NINE MILE POINT NUCLEAR STATION, UNIT NO. 1

AMENDMENT TO FACILITY OPERATING LICENSE

Amendment No. 85
License No. DPR-63

ATTACHMENT TO LICENSE AMENDMENT NO. 85

FIGURE 3.2.2.a

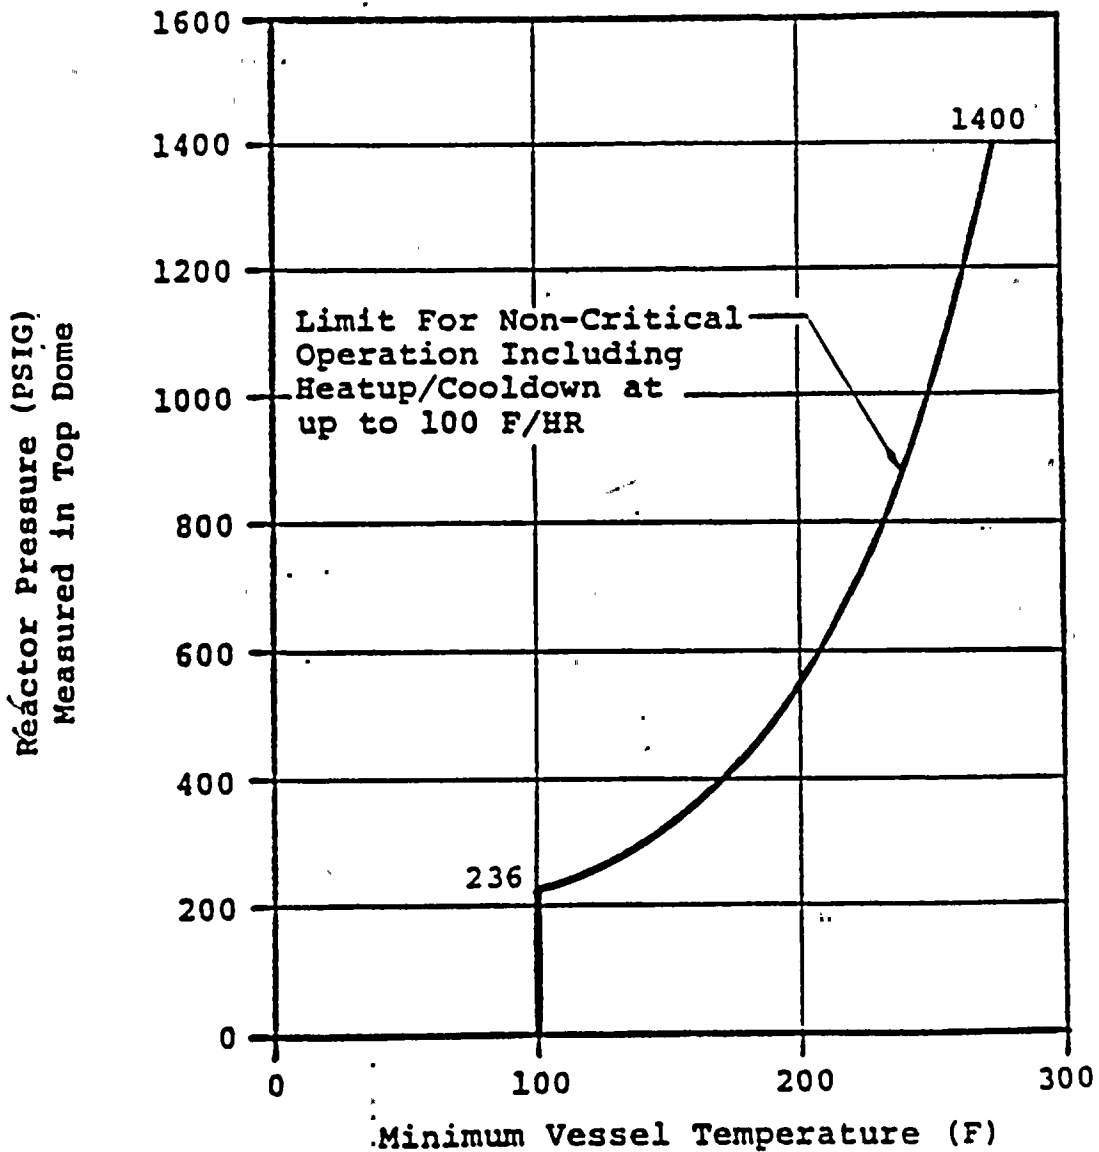
- a. During reactor vessel heatup and cooldown when the reactor is not critical, the reactor vessel temperature and pressure shall satisfy the requirements of Figure 3.2.2.a.
- b. During reactor vessel heatup and cooldown when the reactor is critical, the reactor vessel temperature and pressure shall satisfy the requirements of Figure 3.2.2.b. except when performing low power physics testing with the vessel head removed at power levels not to exceed 5 mw(t).

LIMIT FOR NON-CRITICAL OPERATION
INCLUDING HEAT-UP/COOLDOWN AT
UP TO 100F/HR

<u>PRESSURE (psig)</u>	<u>TEMPERATURE (F)</u>
236	100
300	135
350	154
400	170
450	182
500	192
550	201
600	209
650	217
700	223
750	229
800	234
850	240
900	244
950	248
1000	253
1050	256
1100	260
1150	263
1200	267
1300	273
1400	279

FIGURE 3.2.2.b

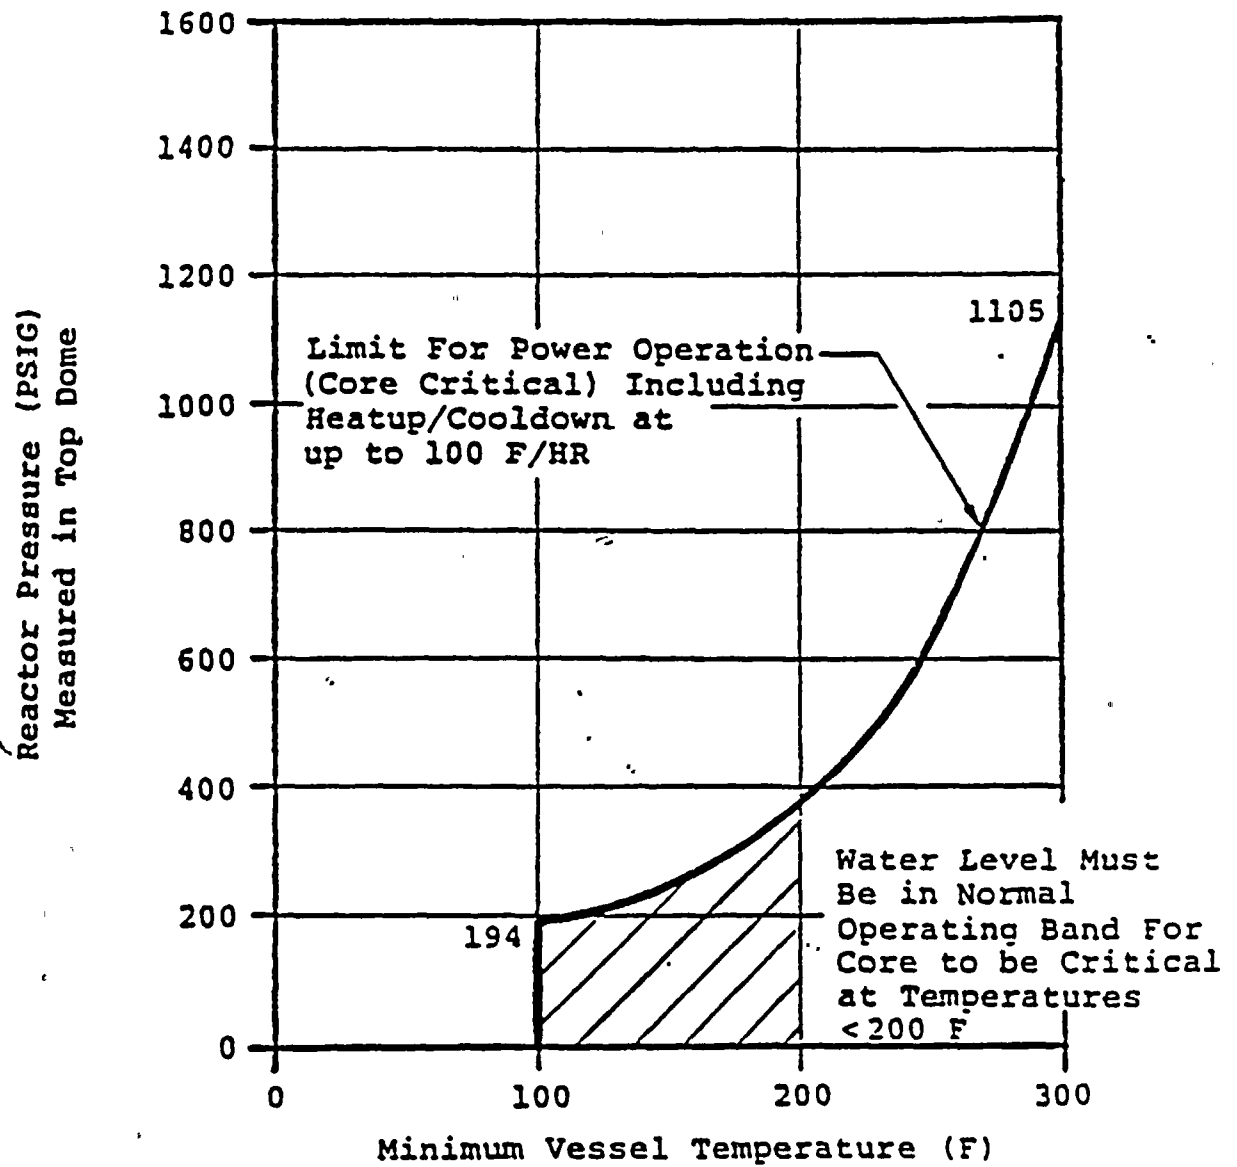
LIMIT FOR POWER OPERATION
(CORE CRITICAL) INCLUDING HEAT-UP/
COOLDOWN AT UP TO 100F/HR

<u>PRESSURE (psig)</u>	<u>TEMPERATURE (F)</u>
194	100
250	150
300	176
350	194
400	210
450	222
500	232
550	241
600	249
650	257
700	263
750	269
800	274
850	280
900	284
950	288
1000	293
1050	296
1100	300
1150	303
1200	307
1300	313
1400	319

FIGURE 3.2.2.c

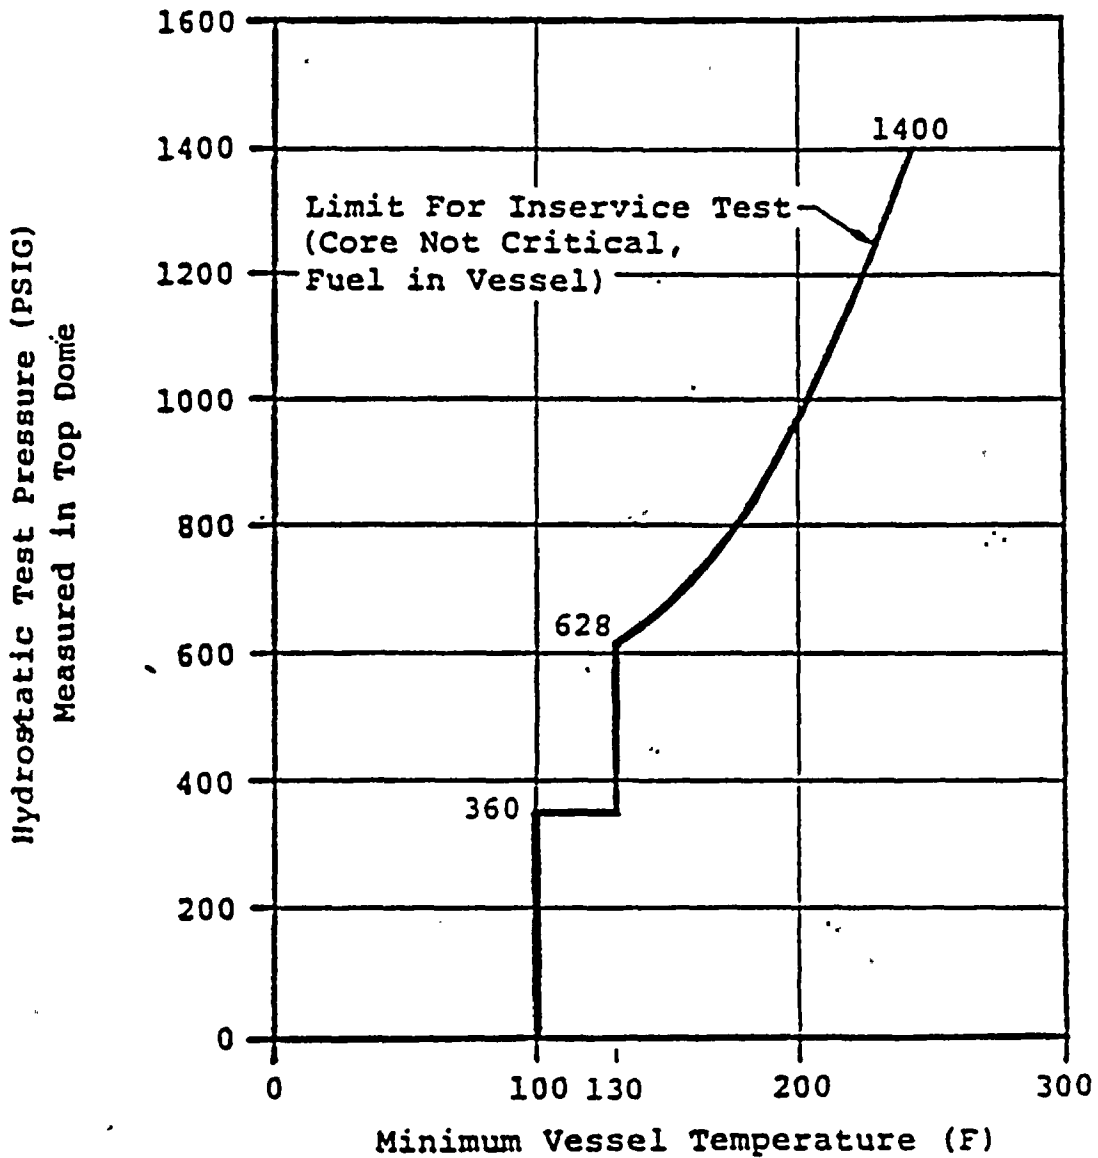
- c. During hydrostatic testing, the reactor vessel temperature and pressure shall satisfy the requirements of Figure 3.2.2.c. if the core is not critical.
- d. The reactor vessel head bolting studs shall not be under tension unless the temperature of the vessel head flange and the head are equal to or greater than 100F.

LIMIT FOR IN-SERVICE TEST
(CORE NOT CRITICAL, FUEL IN VESSEL)

<u>PRESSURE (psig)</u>	<u>TEMPERATURE (F)</u>
360	100-130
628	130
700	152
800	174
900	190
1000	204
1050	210
1100	215
1150	220
1200	225
1300	233
1400	241
